North America LLC **Customer Advisory Letter**

Subject; Brake Clevis Pin

This documentation applies to FCCC, MT45/MT55 and 2015 to 2017 Year vehicles.

**Correctly installed
cotter pin**

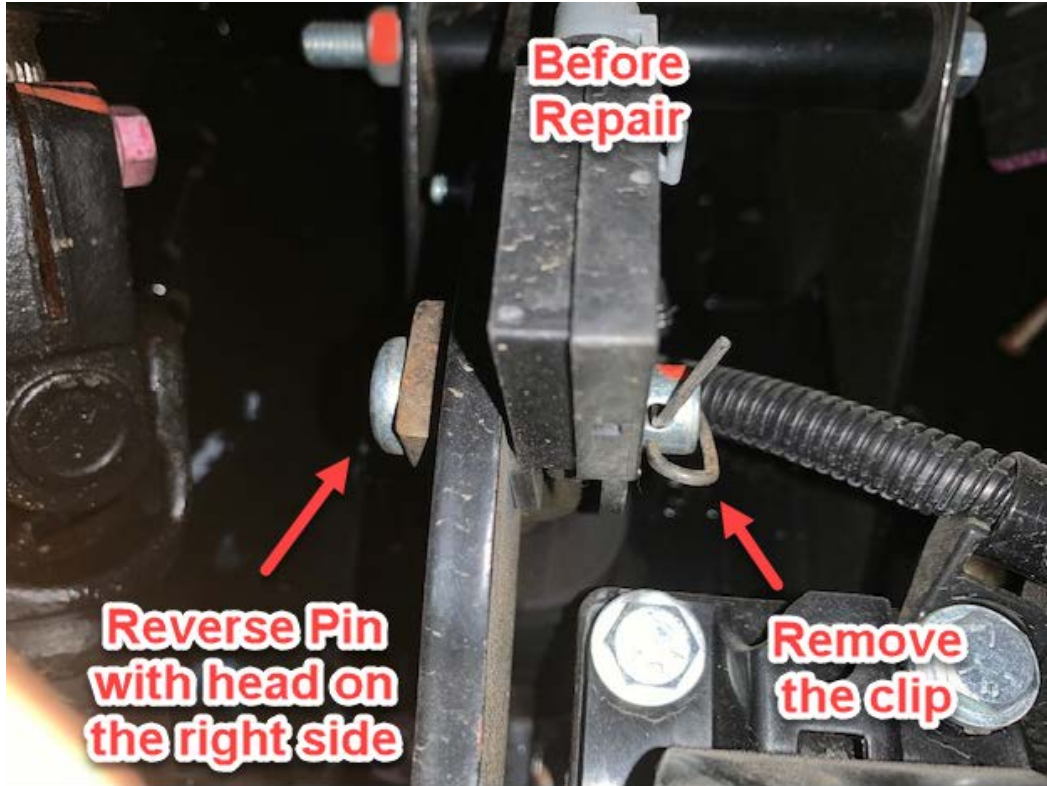
The clip holding the clevis pin can be rotated where it is close to the TPS (throttle position sensor) and mounting that could cause the clip to bend and/or break.

Remove the clip holding the clevis pin, note if the clip was bent, missing or damaged. Record this on your repair order. Remove the clip or retainer from the clevis pin, remove the clevis pin keeping the washer at the head of the pin, reverse the clevis pin by reinstalling the pin opposite from how it was removed. This will move the retaining hole of the clevis pin away from the TPS. Use a 1/8 inch cotter pin bending the cotter pin tightly around both sides of the clevis pin.
